**PINEHURST DELANY'S ADDITION TO SPRINGHILL
SUBDIVISION, BLOCK 72, RESUBDIVISION OF LOTS
1, 2, 3, & 4**

APPLICATION NUMBER 8 DATE August 3, 2006

REQUEST Subdivision

DETAIL SITE PLAN

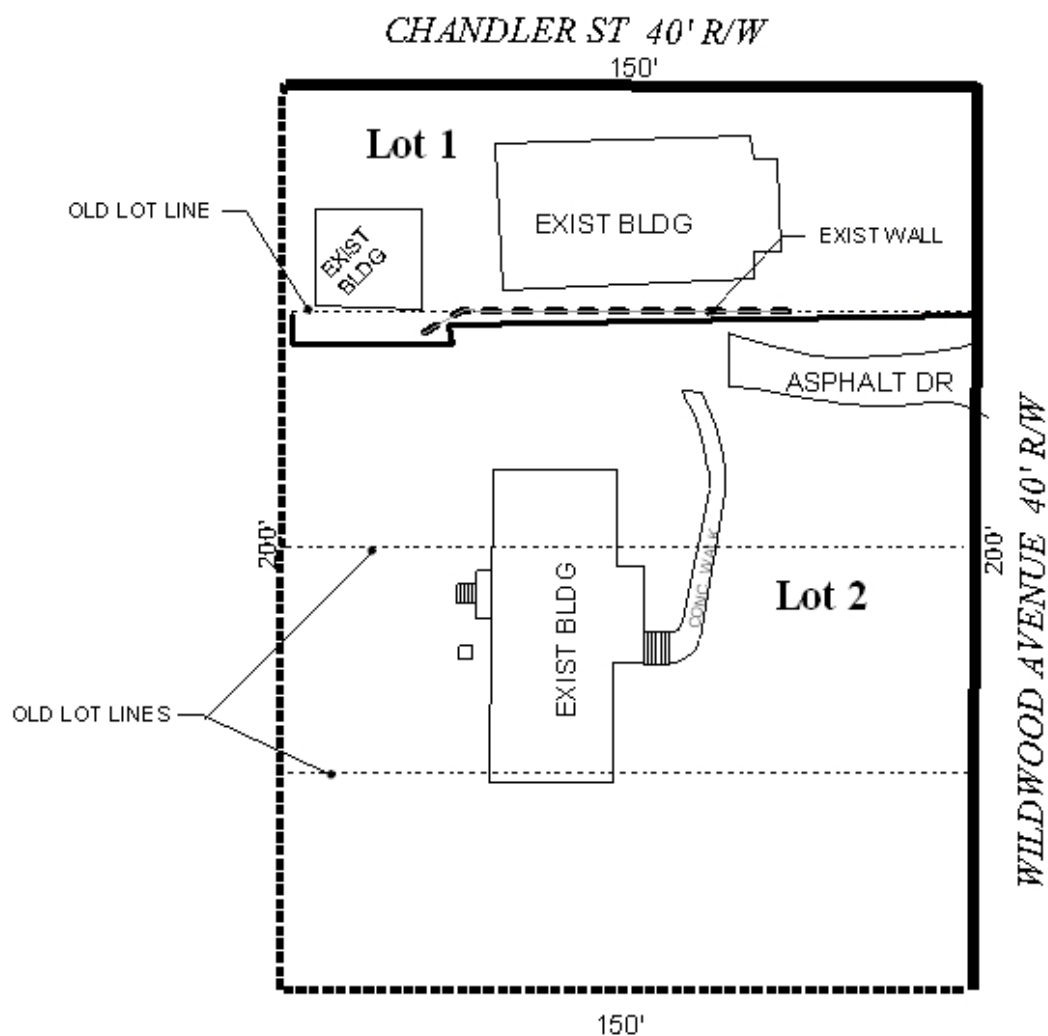
Fire Department Comments: No fire hydrants shown on plans, may require installation of fire hydrants.

This subdivision application, as proposed, will adjust the South property line of the existing Lot 1 to create a new Lot 1, resulting in all structures on Lot 1 being at least 7.14 feet from the South property line. The new property line is depicted as having a 4.8 foot \pm jog to the North, between the rear and the front property lines. It is recommended that this jog be removed, and that the property line instead go straight from the location to the front property line.

The site fronts onto Wildwood Avenue, a minor street with a right-of-way of 40 feet. Wildwood Avenue lacks curb and gutter, and according to Section V.B.14. of the Subdivision Regulations should have a right-of-way of 60 feet. Furthermore, the minimum building setback line is not depicted on the preliminary plat. Therefore, the plat should be revised to depict a minimum building setback line that reflects an additional setback sufficient to provide a right-of-way width of 30 feet as measured from the centerline of Wildwood Avenue; thus the setback line should be drawn approximately 35 feet from the Wildwood Avenue property line, in conformance with Section V.D.9. of the Subdivision Regulations.

Based on the preceding, the plat is recommended for Tentative Approval, subject to the following conditions: 1) revision of the plat to remove the jog in the property line dividing proposed Lots 1 and 2; 2) depiction of the minimum building setback line, to be located so as to provide a minimum right-of-way width of 30-feet, as measured from the centerline of Wildwood Avenue, plus the required 25-feet from the adjusted right-of-way edge (thus 35-feet); and 3) full compliance with all other municipal codes and ordinances.
